REPORT SUPPLEMENT TO
INVESTIGATION OF NORTH PHOENIX MOUNTAINS
FLOOD DETENTION BASINS

CITY OF PHOENIX, ARIZONA

April 17, 1973

RE: INVESTIGATION OF NORTH PHOENIX MOUNTAINS FLOOD DETENTION BASINS,
PROJECT NO. ST-71185.00.

PLATE NO. I

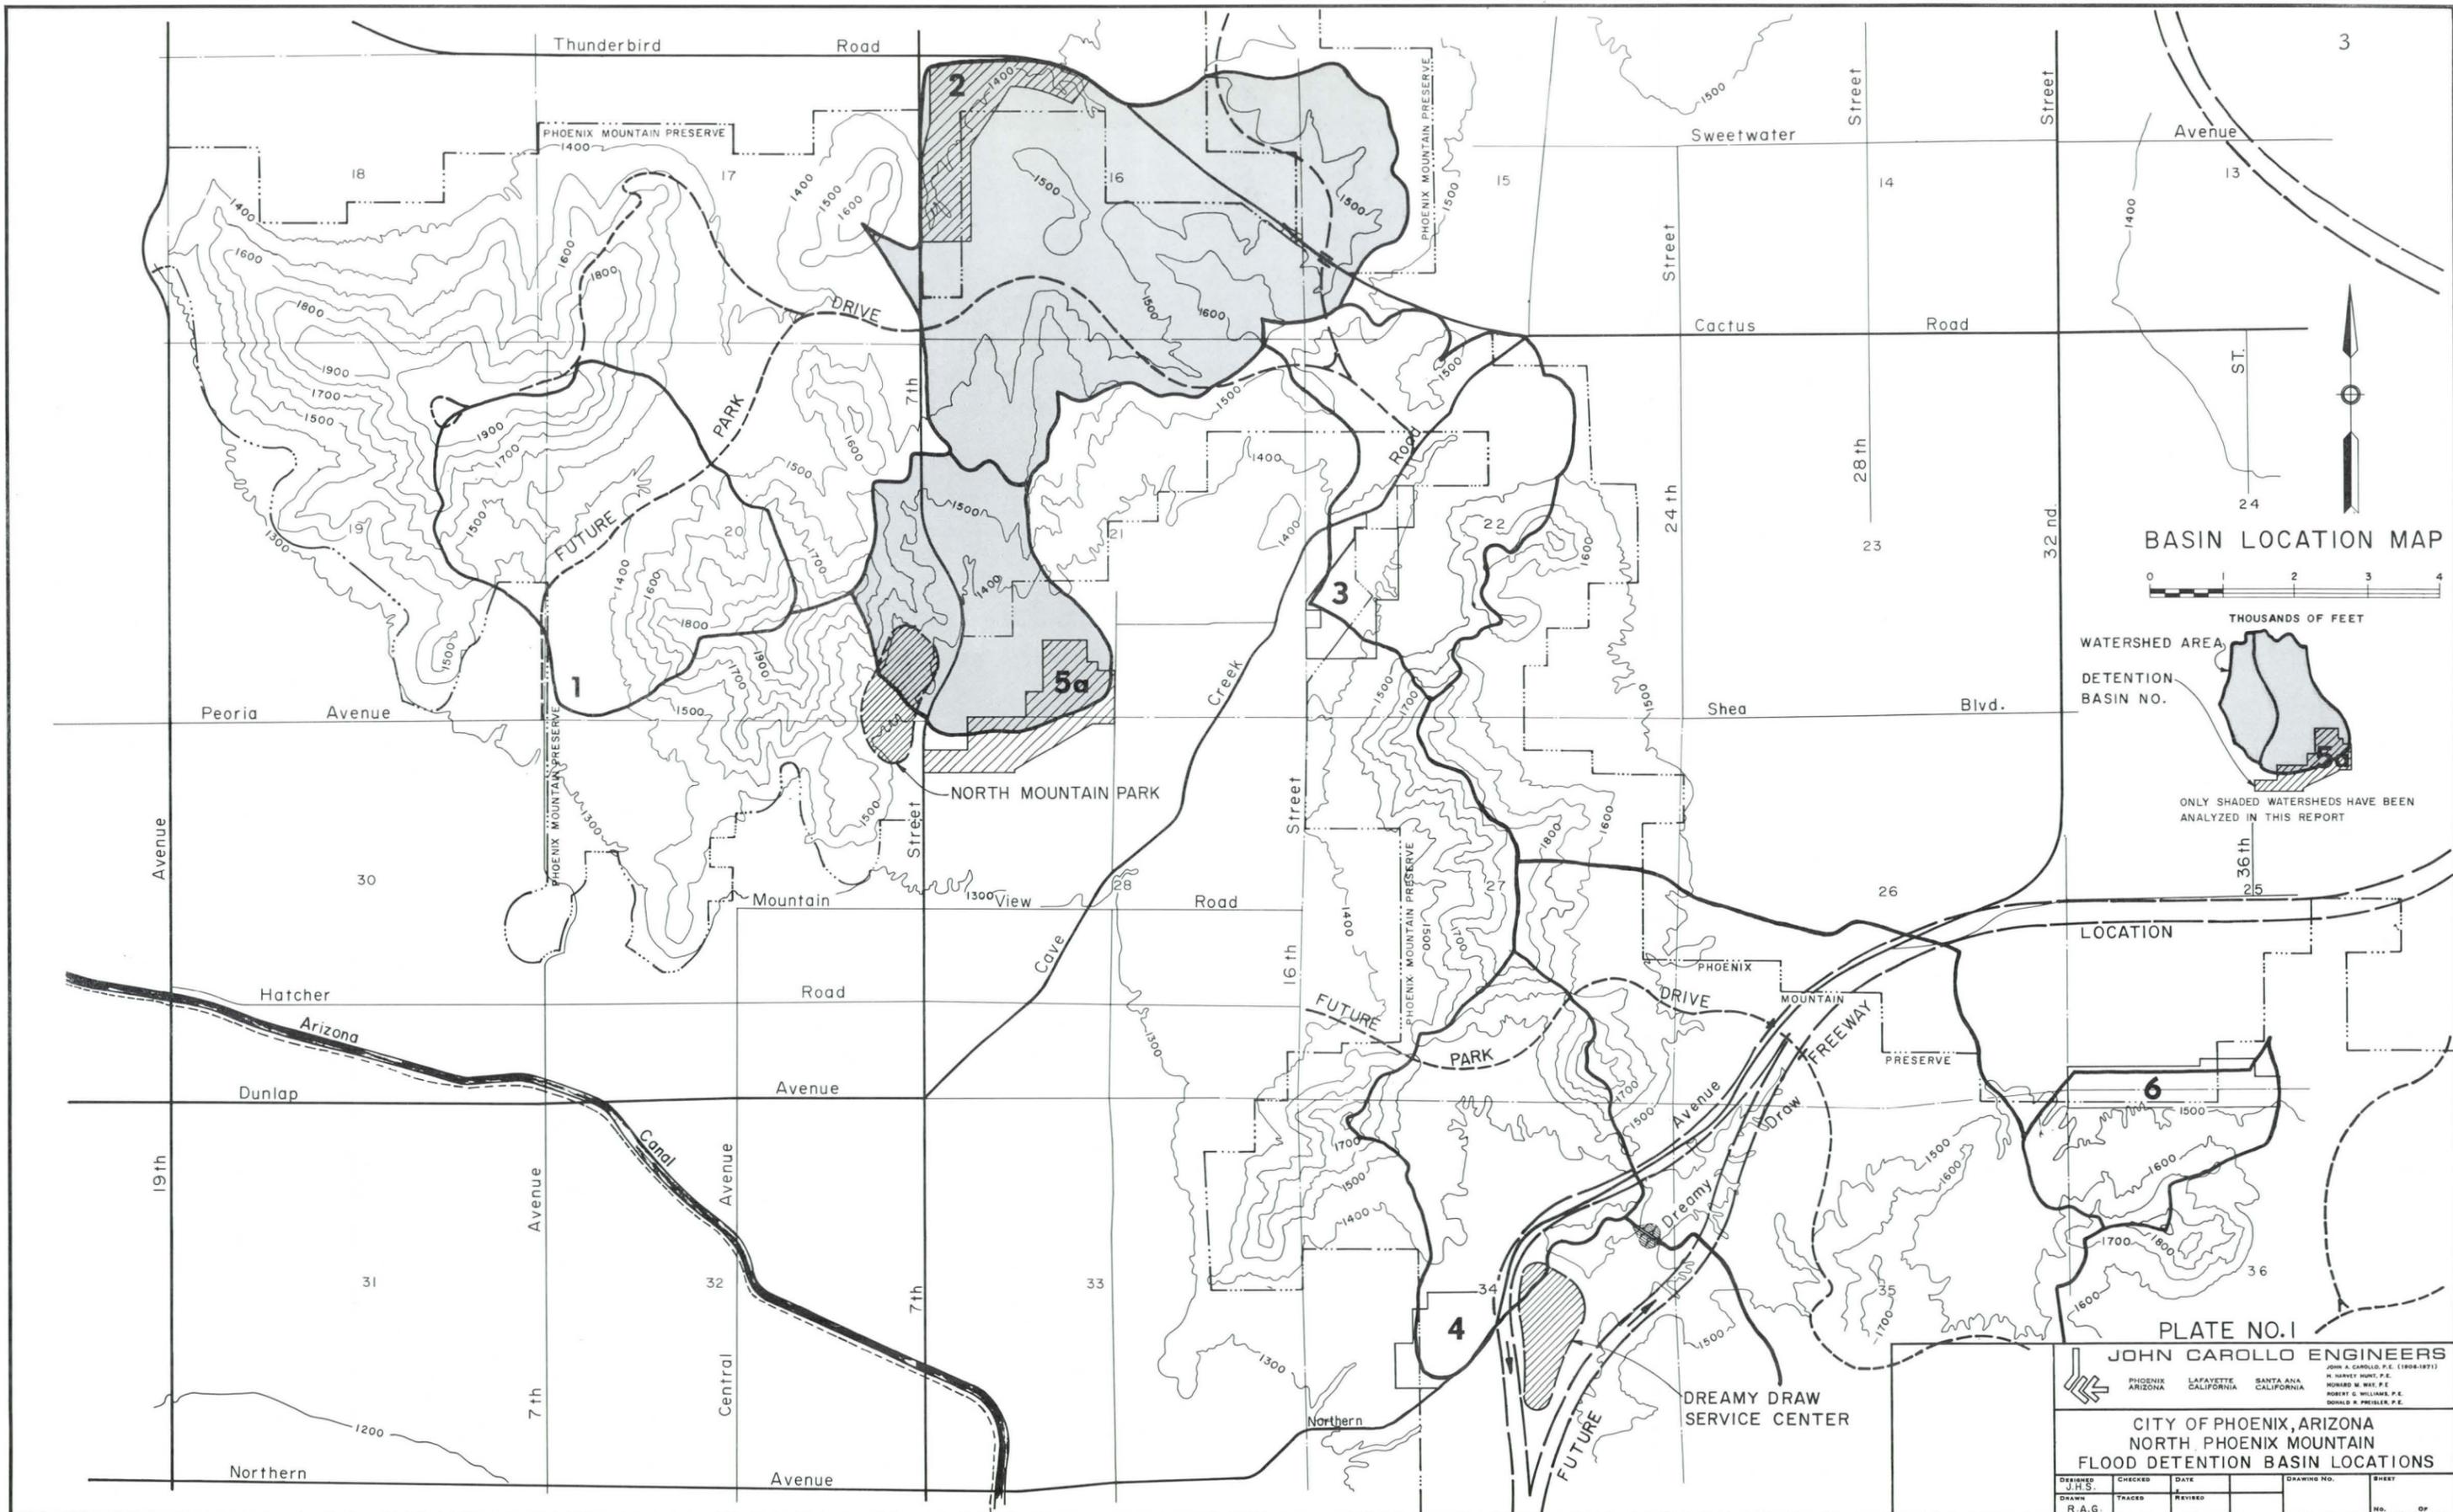
Plate I indicates a Dreamy Draw Service Center. It is my understanding this Service Center is not to be established. I have no other comments.
